# UNITED STATES PATENT AND TRADEMARK OFFICE

APPLICATION NO.	FILING DATE	FIRST NAMED INVENTOR	ATTORNEY DOCKET NO.	CONFIRMATION NO.
10/089,015	03/25/2002	Hideki Fujiwara.	F-7369	9145

**Office Action Summary**

### DETAILED ACTION

FIG. 7

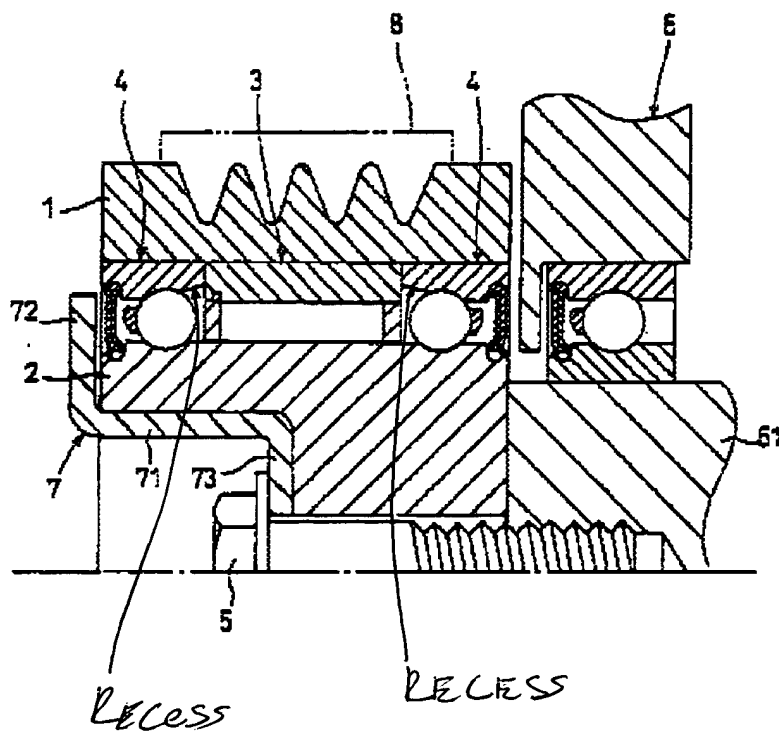
In addition, Wagner et al. does not disclose a recess between the clutch and the roller. GB (2,330,884) disclose a pulley unit having a clutch (34) and a roller (43) in an annular space between a pulley body (1) and a shaft (20) and a recess (see attached drawing) in the inner surface of the outer raceway between the clutch and the roller in order to obtain easy access of the bearing. Therefore it would have been obvious to one of ordinary skill in the art at the time of the invention to further modify the inner surface of the pulley body of Wagner et al. so that it includes a recess between the clutch and the roller in view of GB (2,330,884) in order to obtain easy access of the bearing into the raceways.

Regarding the remarks relating to claim 8 to GB (2,330,884). GB (2,330,884) clearly shows the recess as indicated in the attached drawing below.
